## 4 Masterplan & Public Realm

# 6 Comparison Drawings

The following pages contain a series of comparison drawings to allow the amended design changes to be reviewed directly alongside the original approved planning drawings.

### 6.2.1 Lower Ground Floor Plan

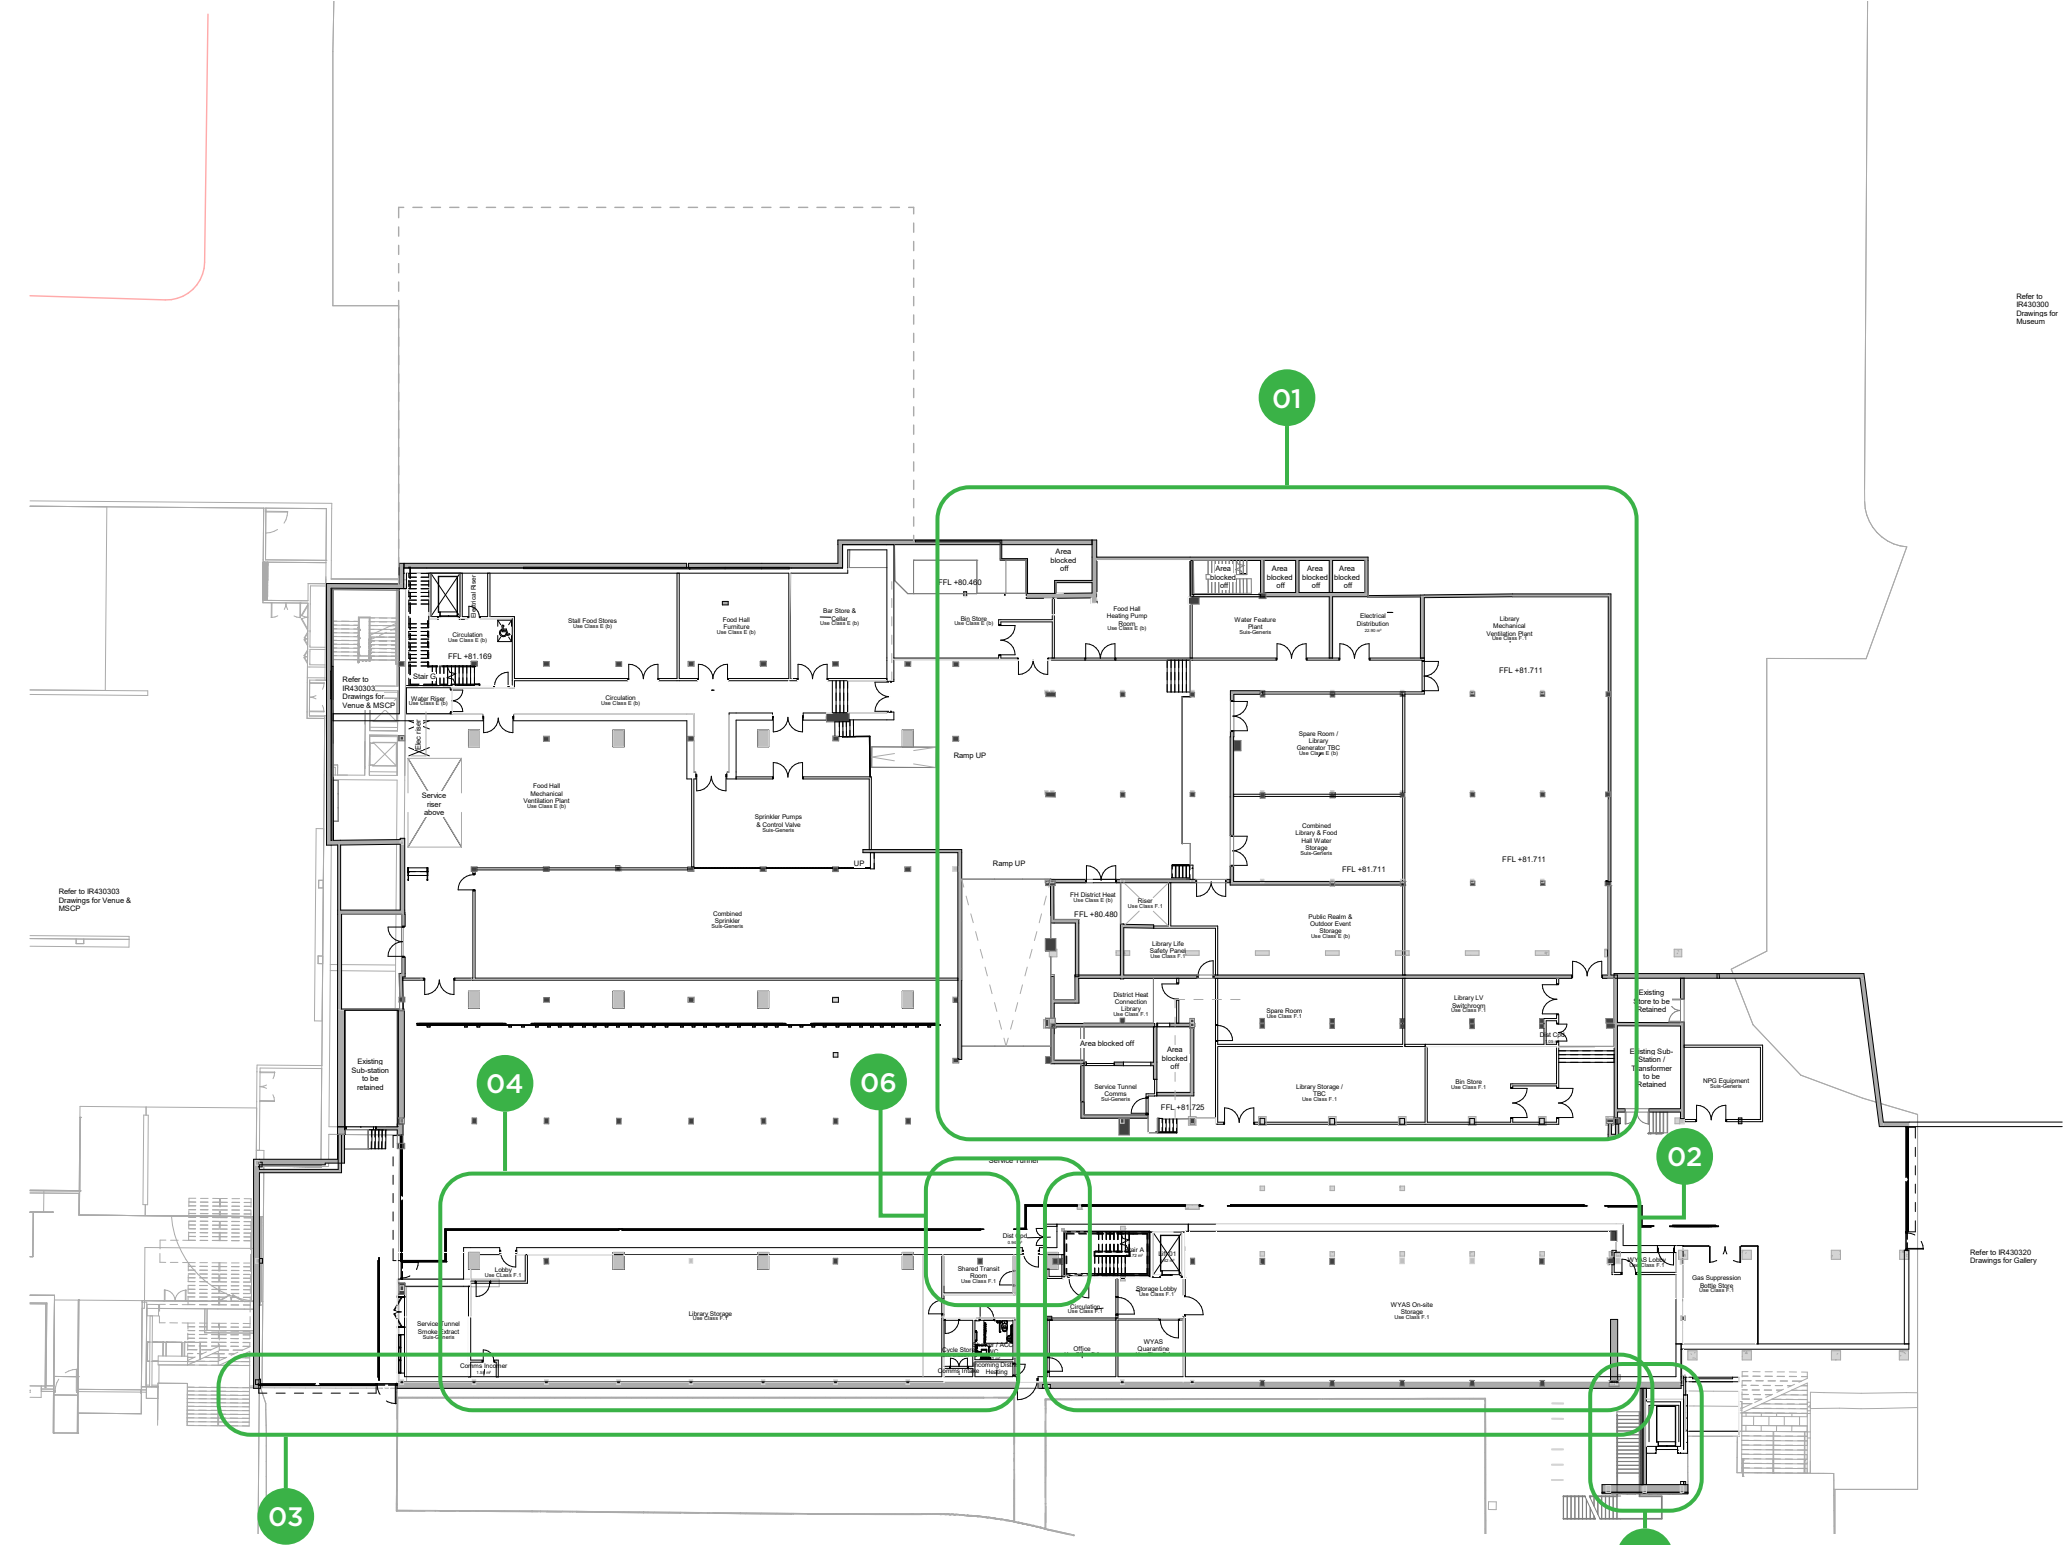
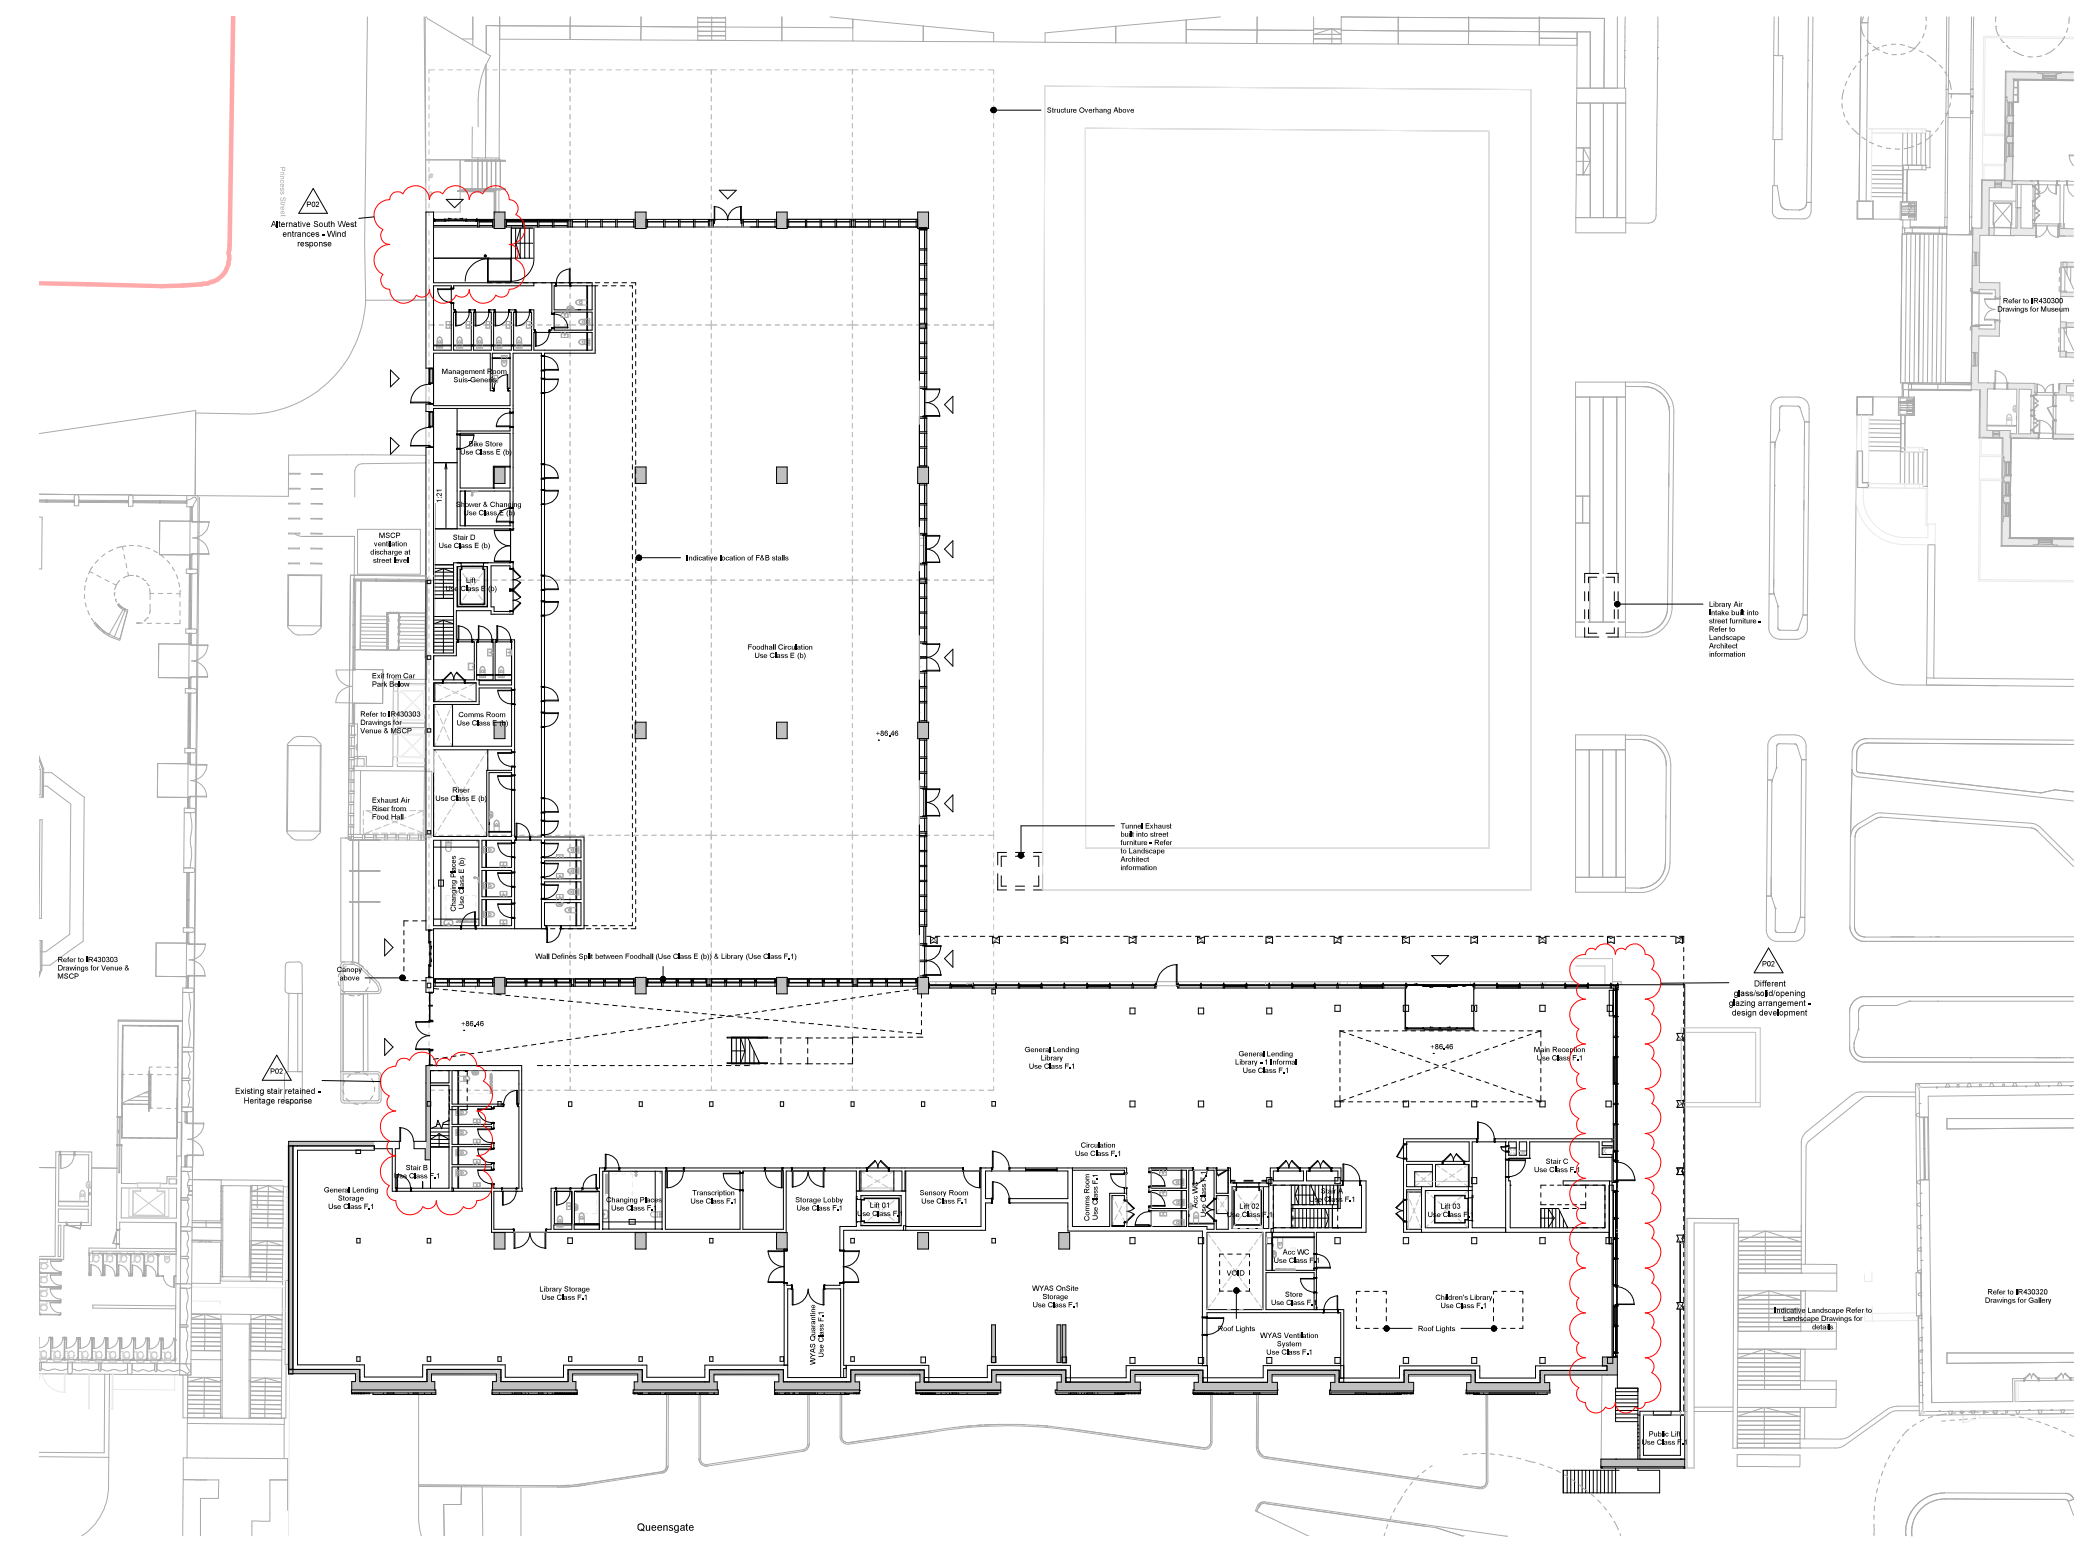
- 01 Area of retained structure including retaining walls/columns/foundations/slab (at lower and upper ground floor).
- 02 Relocation of WYAS storage to this level (higher floor loading and floor to floor height).
- 03 Omission of glazed windows and doors to Queensgate.
- 04 Relocation of majority of Library storage to this level (higher floor loading and floor to floor height).
- 05 Relocation of lift to avoid clash with existing below ground sub-structure.
- 06 Omission of one internal lift in Library.
